SUBJECT: EVALUATION OF THE LANDSMAN CONCERNS FOR MIDLAND

SUBJECT: EVALUATION OF LANDSMAN'S CONCERNS REGARDING
DIESEL GENERATOR BUILDING AT MIDLAND

SUBJECT: COMMENTS ON OCTOBER 21, 1983 REPORT BY INDEPENDENT
TASK GROUP REVIEW OF THE DGB AT THE MIDLAND PLANT

Subject: Review Comments on October 21, 1983 Report by Independent Task
Group on the DGB
Plant: Midland Plant Units 1 and 2, 50-329/330 ..
Prepared by: Joseph Kane, NRR, DE, SGEB

FIGURE 6-2
DIESEL GENERATOR BUILDING
SETTLEMENT MARKER LOCATIONS

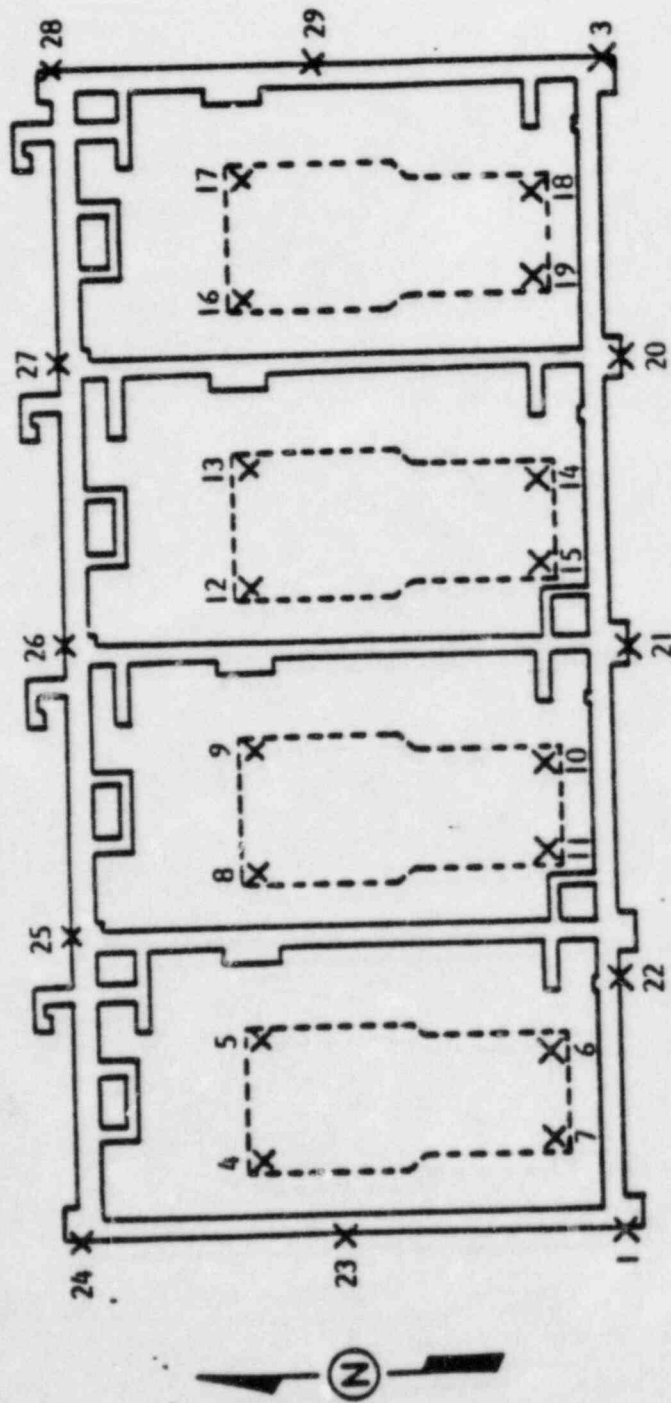
The building settlements have been monitored at close intervals during the construction period and thereafter. Figure 6-2 presents the location of the settlement markers indicating where survey measurements are taken. The data spans over a period of 5 years with measurements taken approximately every other week. This large amount of data allows one to follow the settlement history through the stages of construction, duct bank isolation, surcharge period, dewatering, and up through the present. It also provides a means of assessing potential random and systematic errors in the measurements. The Midland project has concluded that significant errors exist in the measurements due to a variety of circumstances. A study of these data is presented in the following section.

FIGURE 6-3
DIESEL GENERATOR BUILDING
SOUTH WALL
SETTLEMENT INCREMENT

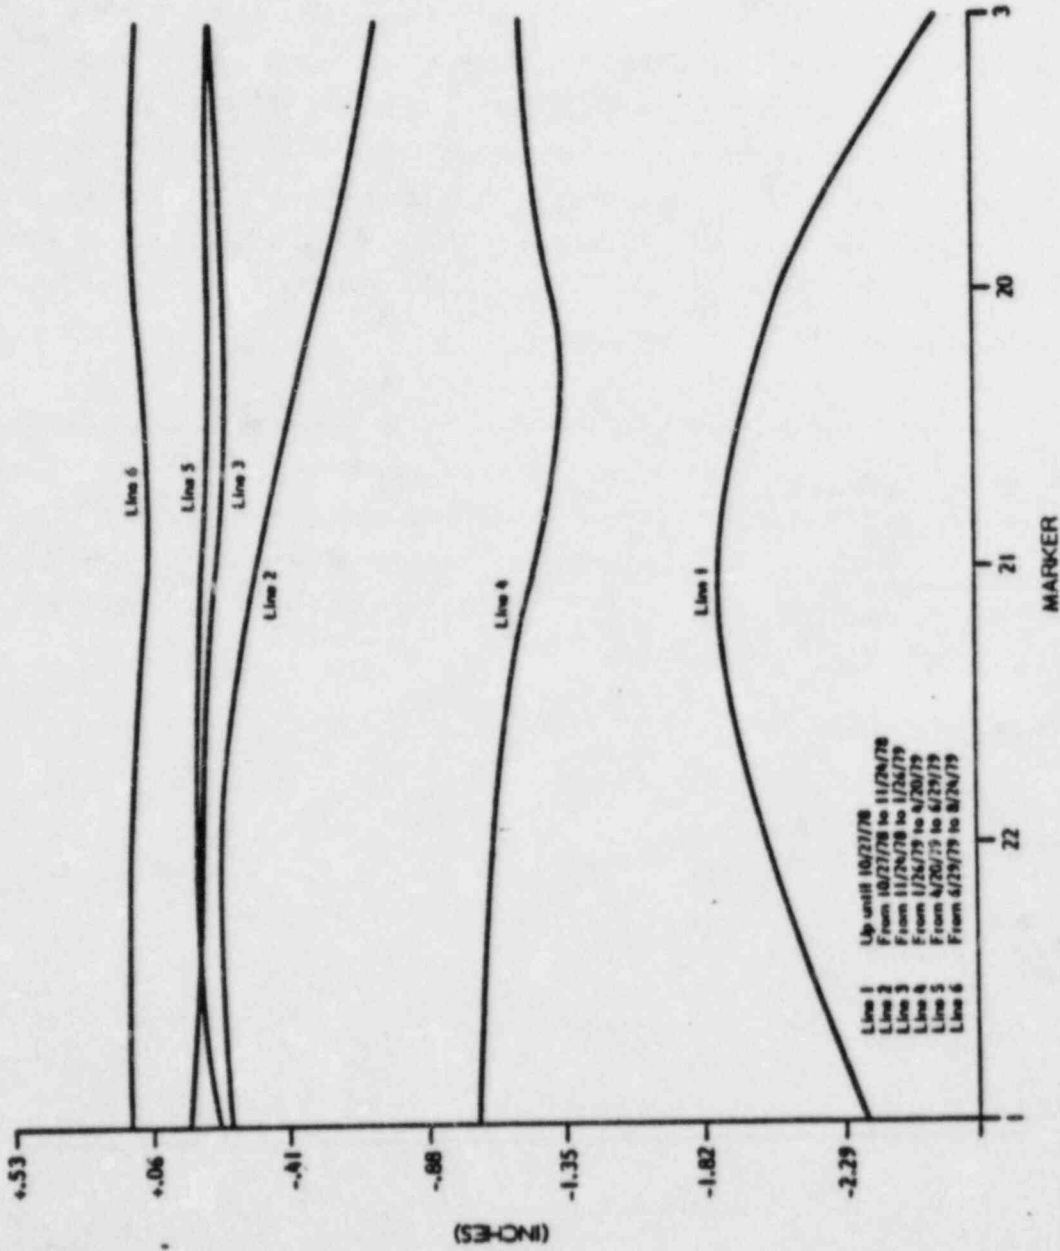
Figure 6-3 shows the incremental settlement for 6 time periods between July 1978 and August 1979 for the south wall of the DGB. The first three measurements show large differential deformations and introduction of curvature in the wall. The latter ones show stabilization of differential settlements implying that the wall is still settling but as a rigid unit, introducing little additional in-plane bending. For more recent recordings the stabilizing trend is even more noticeable. Study of the foundation curvature variation and deformation of the building with respect to its rigid body motion point toward the same trend. This is supported by an evaluation discussed in reference 4, where it was noted that the settlements occurring during the time periods represented by lines c and d (reference 4, figure DGB-7), were those that are expected of a rigid body. In figure DGB-7, line c represents settlement during the surcharging period (1/79 - 8/79) and line d represents estimated settlement during the post-surcharge period (9/79 - 12/2025). The point here is that the early cracking occurred when the building was only partially completed. Upon completion, the five sided (four walls and a roof) structure is now responding as a stiffer, essentially rigid body as would be expected.

Hence during its construction stage, the building underwent substantial differential settlement that introduced in-plane curvature in the walls with resulting stress and cracking compounded with normal shrinkage cracking. As the building was completed and the concrete aged, its tended to behave more and more as a rigid unit, the whole foundation (or building) moving as a plane (or a unit). The recent data indicates that for the last four years the building has generally settled as a rigid body introducing relatively little additional distortion in the structure. We expect this behavior to persist in time.

FIGURE 2

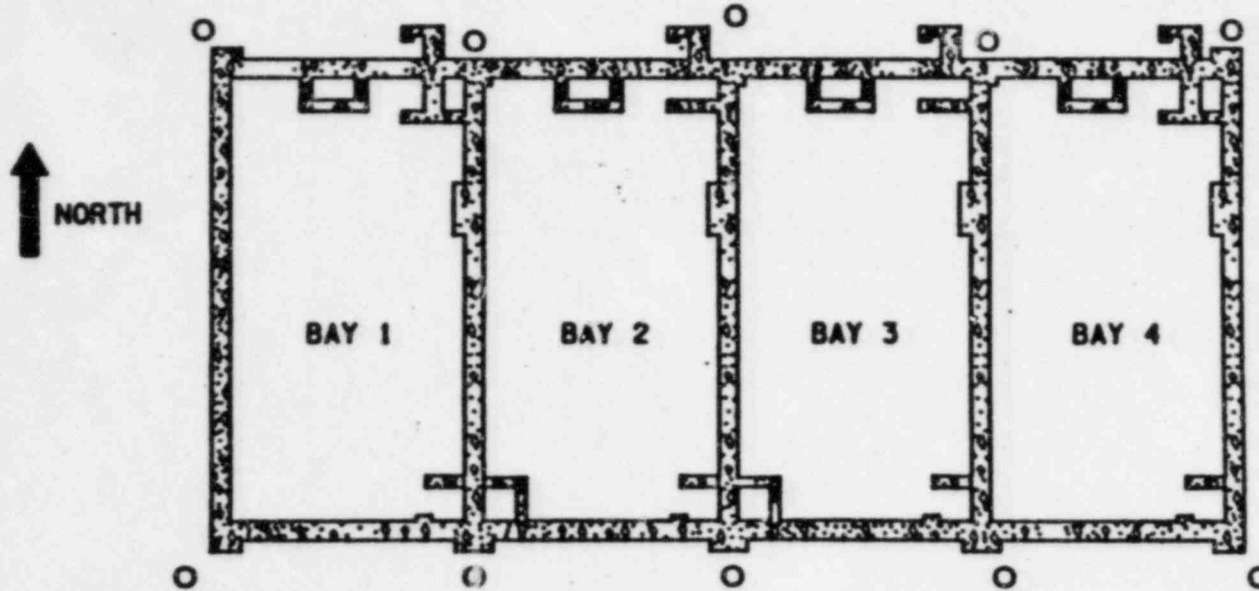
The effects of the remedial measures taken can be observed from the amount of settlement which the DGB has gone through as indicated in Figure 2 and also from the crack sizes and crack patterns of the walls as shown in Figure 3. Details of both settlement and cracking issues are discussed in the following sections.

shown in Figure 2. With the exception of Case 1A which was analyzed by long hand computation and by idealizing the partially completed DGB as a series of individual beams, the other three cases were analyzed by computer through the discretion of the DGB into a number of finite elements as exemplified in Figure 4. Case 1A was accomplished by passing deflection curve through any three measured neighboring settlement points and selecting the one with the largest curvature for moment computation, and eventually, stress determination. This calculation indicated that the measured displacements would result in a maximum rebar stress of 11 ksi. For the other three settlement cases, individual finite-element models were used. For settlement Case 1B, the finite-element model represents the structure as built to el. 662 f 0 in.

DIESEL GENERATOR BUILDING EXECUTIVE SUMMARY
SUMMARY OF ACTUAL AND ESTIMATED SETTLEMENTS
FIGURE ES-14

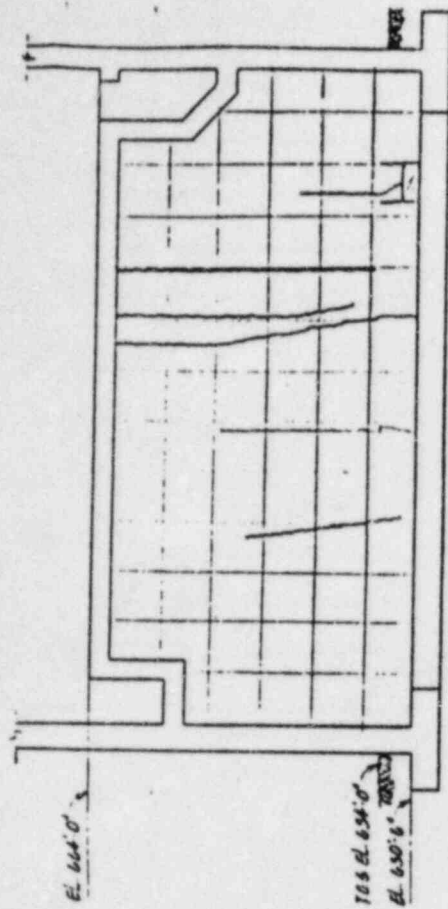
3. Inconsistencies in the documentation of the settlement history needs to be resolved. For example, the Midland Units 1 and 2 Executive Summary dated August, 1983 states that for the July 1978 period, the maximum settlements recorded were 3.5 inches while Figure ES-14 of the same document indicates a maximum of 1.99 inches for the same period.

Peak settlements anticipated at the end of 2025 (actual settlements to date plus secondary settlements from now till then) are specified in Ref. 7 to vary from 4.79 inches (under the NW corner) to 9.33 inches (under the SE corner). However, it should be mentioned that the exact settlement history at the various settlement markers at the DGB is open to question. For example, it is mentioned in Ref. 7 that the maximum settlements in August 1978 were about 3.5 inches. Yet the data used in the stress analyses for the presurcharge period (Figures ES-14 of Ref. 7) indicates peak settlements of only 1.99 inches. It was stated at one of the Bechtel presentations that prior to cutting the duct banks loose from the footing, footings along the North wall actually lifted off from the soil, with the DGB rotating about the duct banks. There is no indication of this behavior in any of the settlement data used in the computations. Ref. 8 lists the settlement increment from 8/79 to 12/2025 to be 2.36 inches under the SE corner of the building. For the same period Ref. 7 lists this data as 1.89 inches. Thus some inconsistencies appear to exist in the various documents.
